ADDENDUM NO. 1

Highway 603 Stabilization Project
Federal Aid Project No. STPR-G211(001)
CRP 2144

The following shall be removed and replaced with the following attachments in the Contract:

SHEET
3
 OF
127

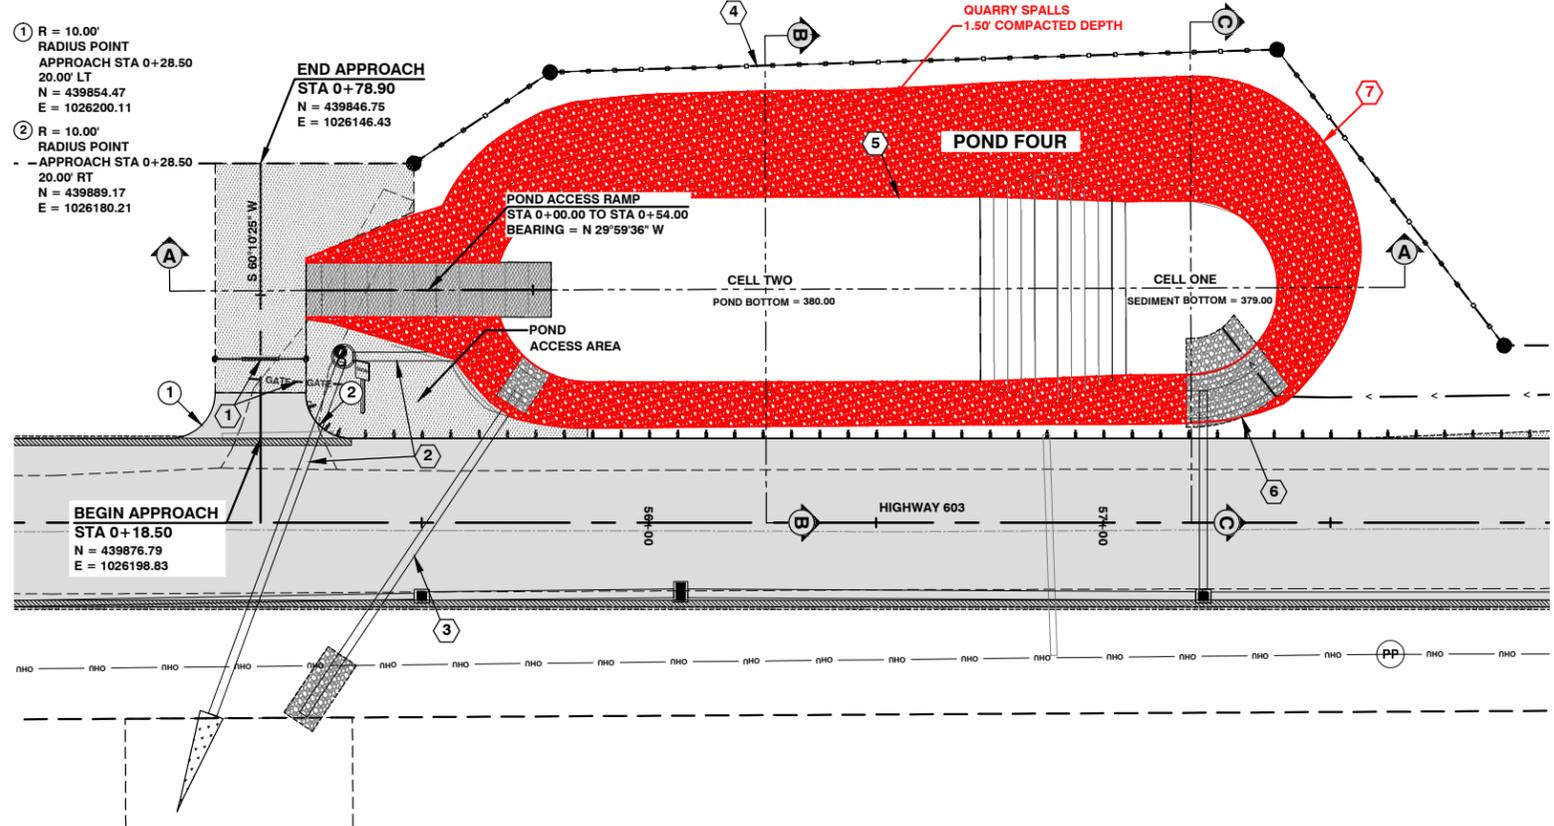
Plan Set Page 3 of 127 (Changing Summary of Quantities)

NO.	DATE	REVISION	BY	APP.
1	3-24-16	ITEM 15 - CHANGED 2142 TONS TO 2917 TONS	J. PIPER

PLAN VIEW

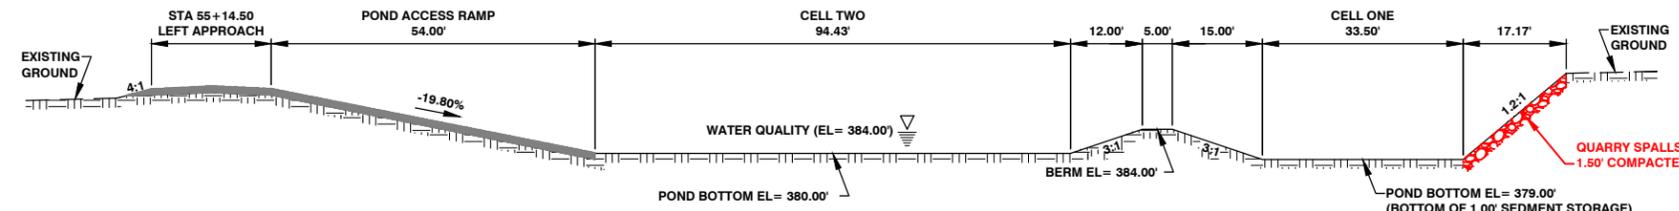
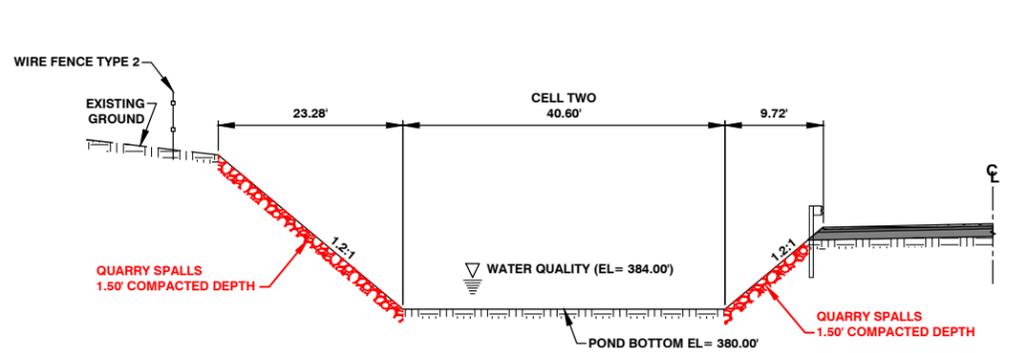
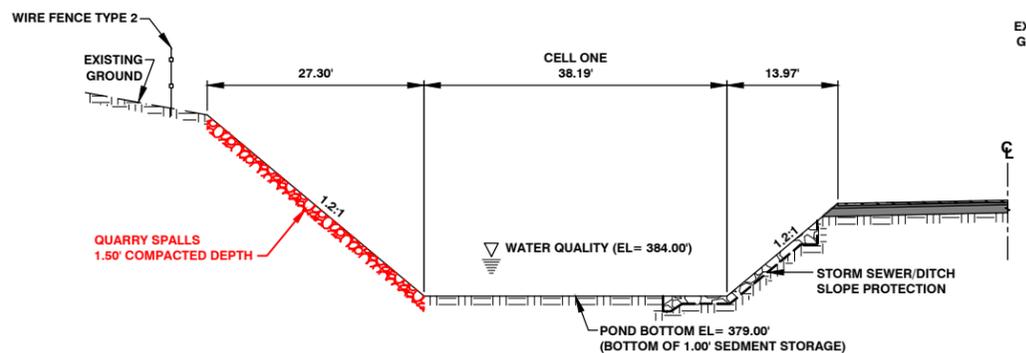
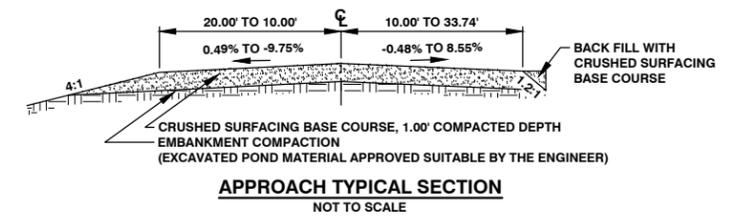
Plan Set Pages 117 of 127 and 118 of 127 (Lining Pond Four with Quarry Spalls)

65.00 S.Y. CONSTRUCTION GEOTEXTILE FOR SEPARATION
30.00 TON QUARRY SPALLS
 - 7 LINE POND WITH QUARRY SPALLS, 1.50' COMPACTED DEPTH
SEE DETAILS ON THIS SHEET AND SHEET 118 OF 127

NO.	DATE	REVISION	BY	APP.
1	3-24-16	LINE POND 4 WITH QUARRY SPALLS	J. PIPER

775.00 TON QUARRY SPALLS

POND OUTLET DRAINAGE SYSTEM
PLAN VIEW

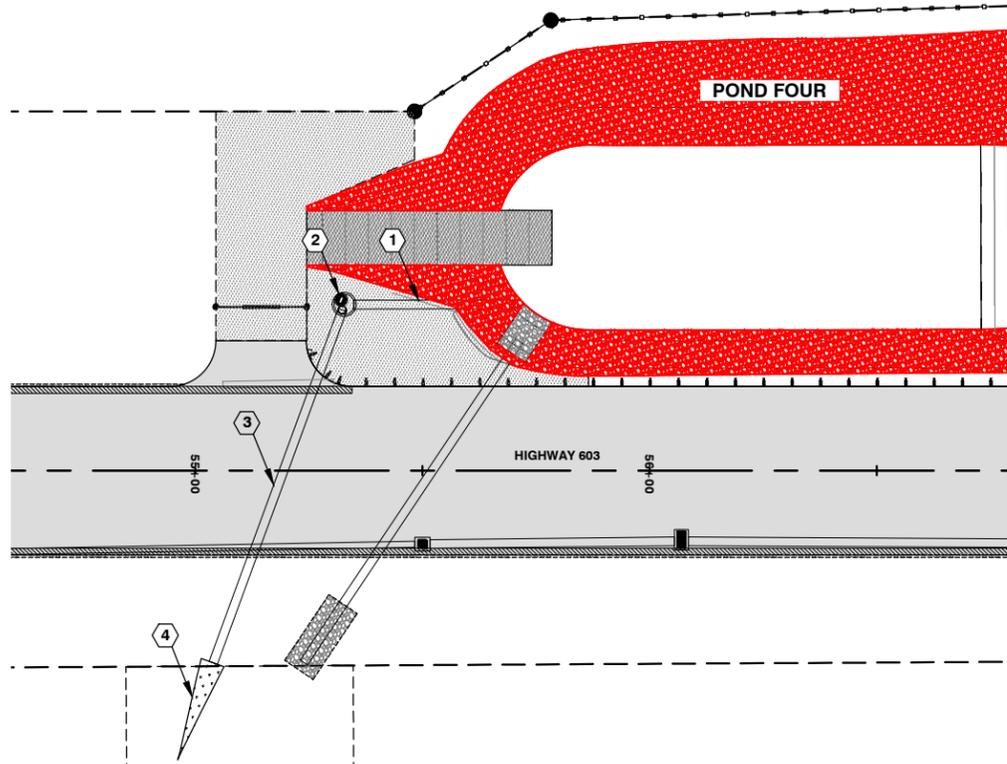
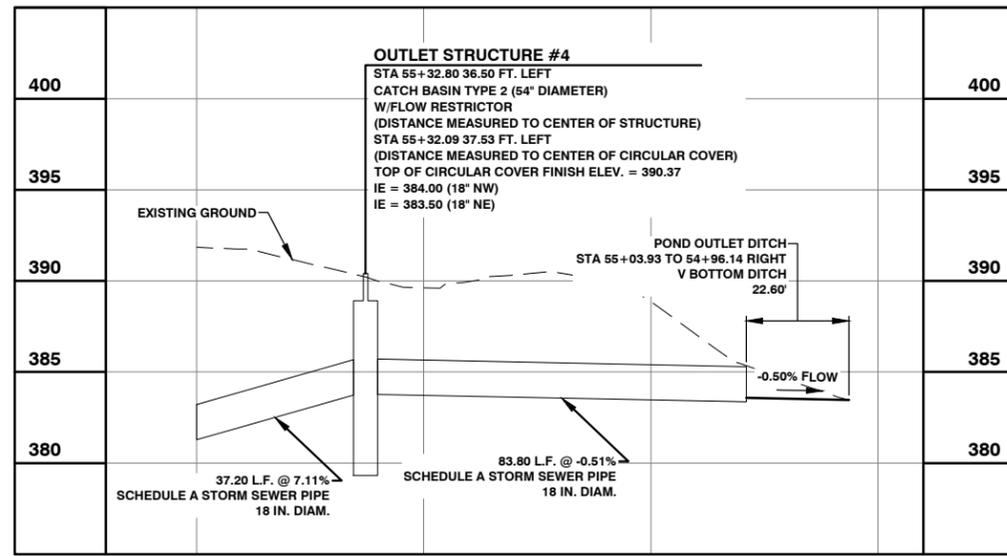
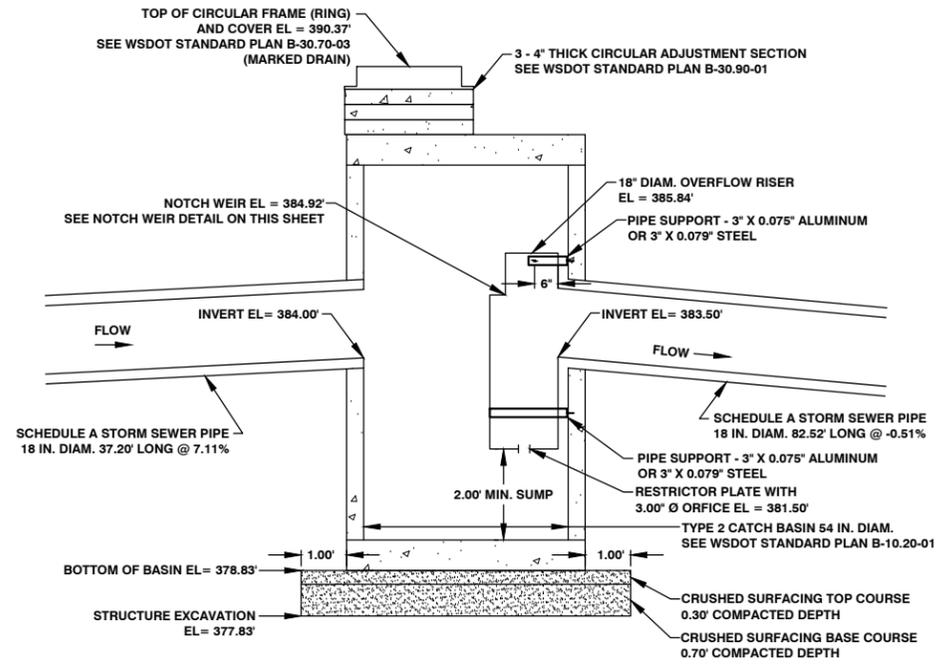
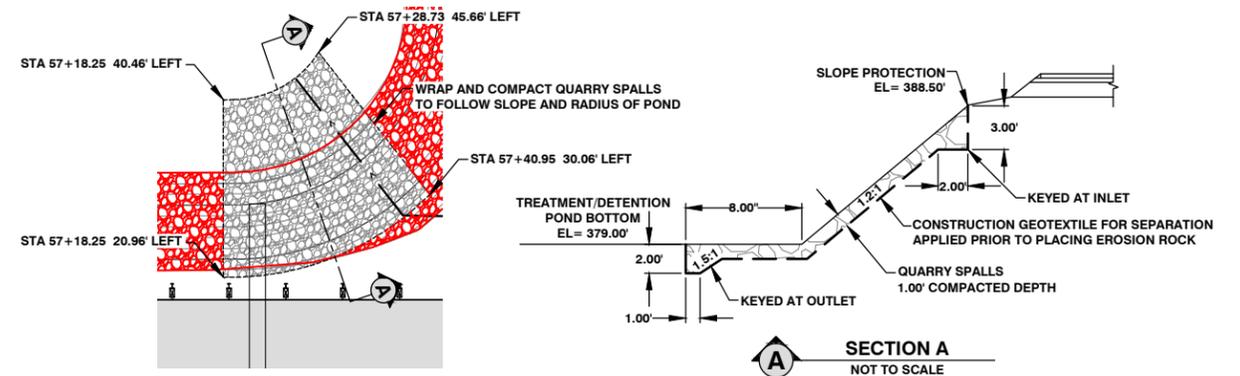
NO.	DATE	REVISION	BY	APP.
1	3-24-16	LINE POND 4 WITH QUARRY SPALLS	J. PIPER
